USWG Approval DRAFT

Consensus Recommendations to Improve Protocols 2 and 3 for Defining Stream Restoration Pollutant Removal Credits

September 1, 2020

Appendix I. Response to Comments

Figure 2. Floodplain Restoration by Raising the Stream Bed (Courtesy: Joe Berg, Biohabitats)

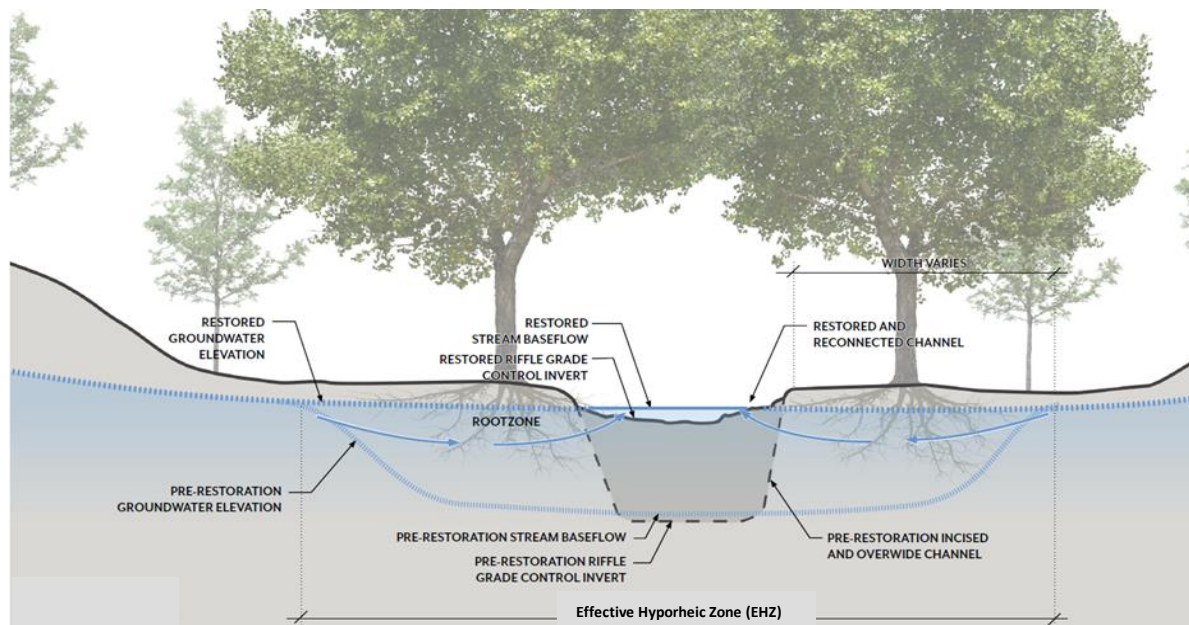
In addition, Figures 2 and 3 do not clearly illustrate these differences. Labels that reflect the narrative descriptions, including the 18 inch criteria, would provide greater understanding.

4. **Figure 2** is a poor sketch because it's not clear or well labeled.

Figure 3. Depiction of EHZ boundaries cross-section and plan view

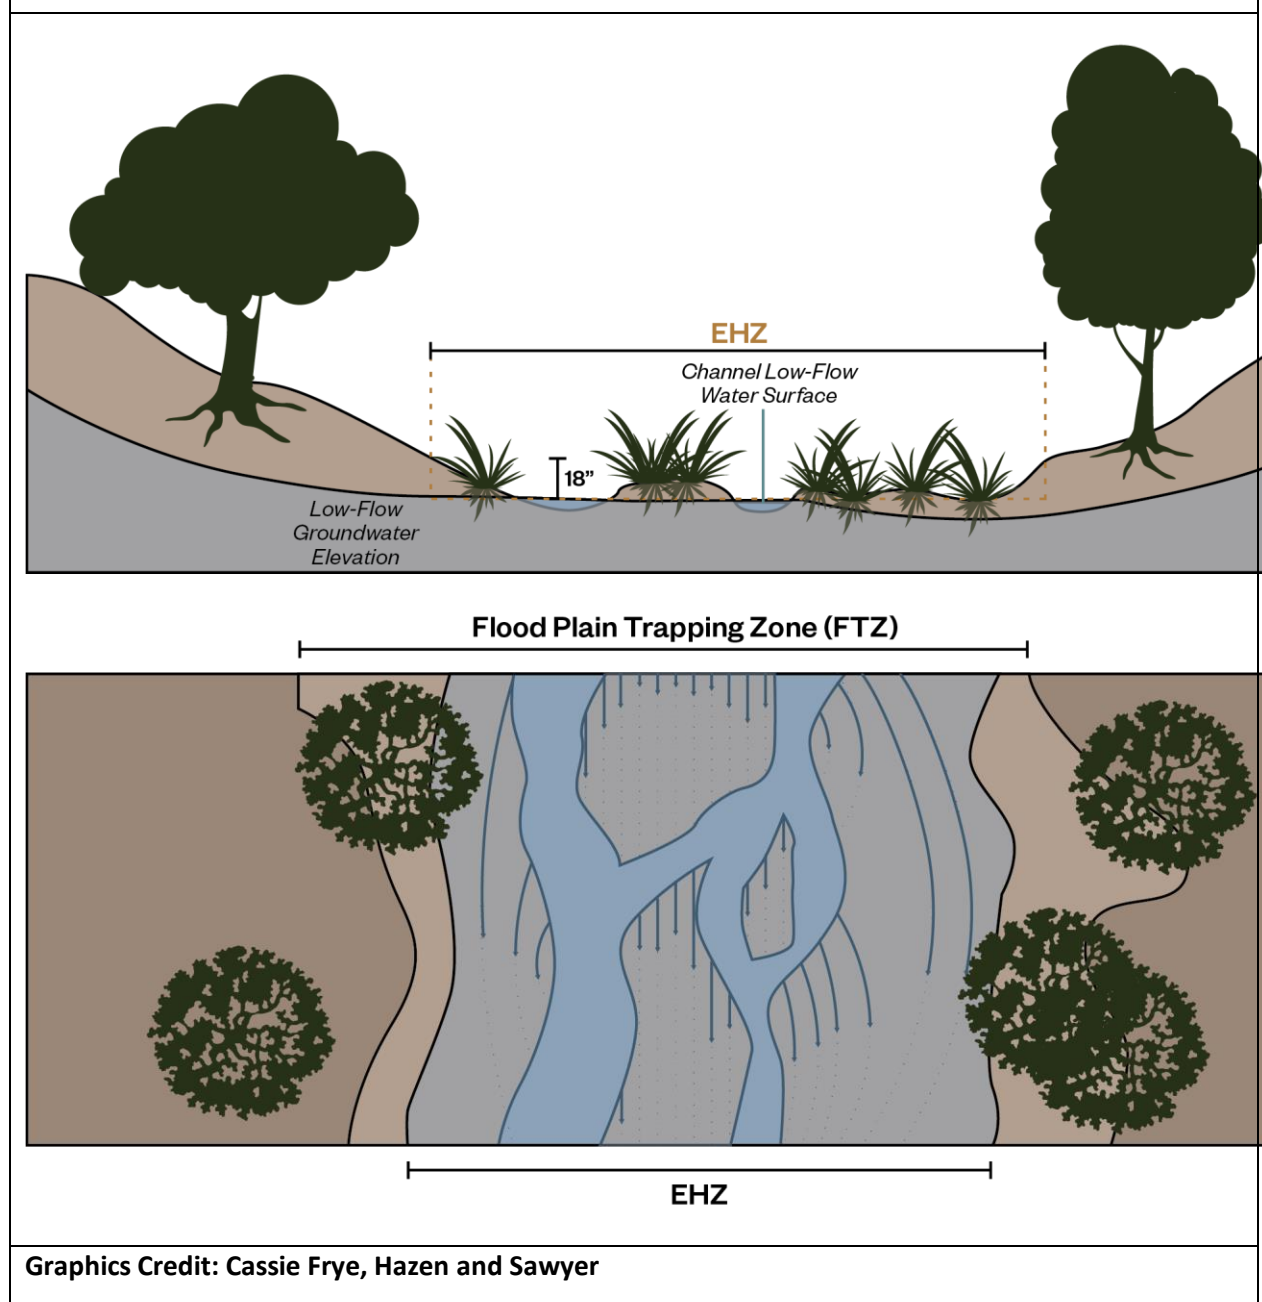
17. In Figure 3, please consider using a detail that does not have the name of a specific practitioner. This affords the specific practitioner a competitive advantage as the Department will be referring our stakeholders to this document.

2. The definition of the HEZ and EHZ needs further clarification both in the narrative and Figure 3 and how it applies to RSB projects. Please see Figure 3 for further details.

Figure 4. Illustration of site-specific discount factors for Protocol 2 (Courtesy: Jeff Hartranft, PA DEP; and Art Parola, University of Louisville).

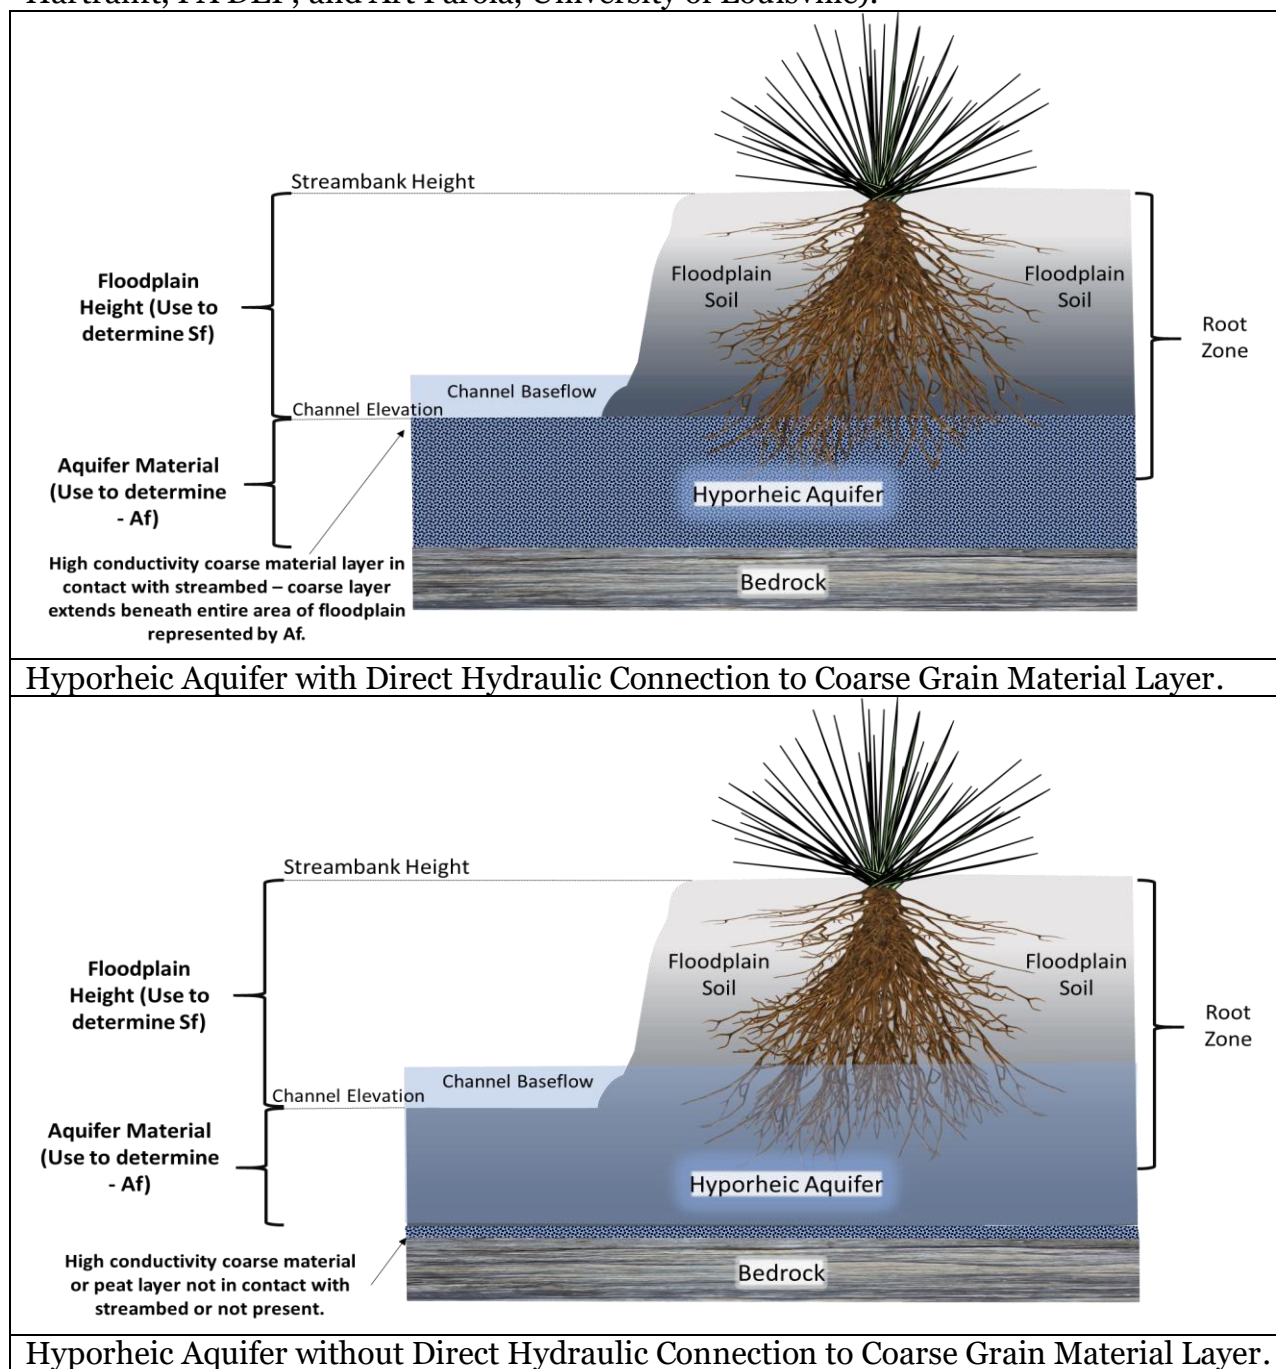
8. Pages 21 and 22: Figures 2, 3 and 4 seem very important yet are not easy to read. Figure 2 is a hybrid of LSR and RSB and contains EHZ and FTZ, but only for LSR, RSB uses old terminology of HB for some reason. Figures 3 has HEZ and EHZ but Figure 4 only specifically labels HEZ. The Text says that EHZ and FTZ are expressed

in Figures 2 and 4 but there's no FTZ in figure 4. Would it be useful to have same type of figure style for both plan view and section view and accurately refer to terms contained in figures in text? In addition, FTZ is only discussed in Protocol 3 - best to have a few robust, complete diagrams to which the two "Protocol" sections refer if possible.
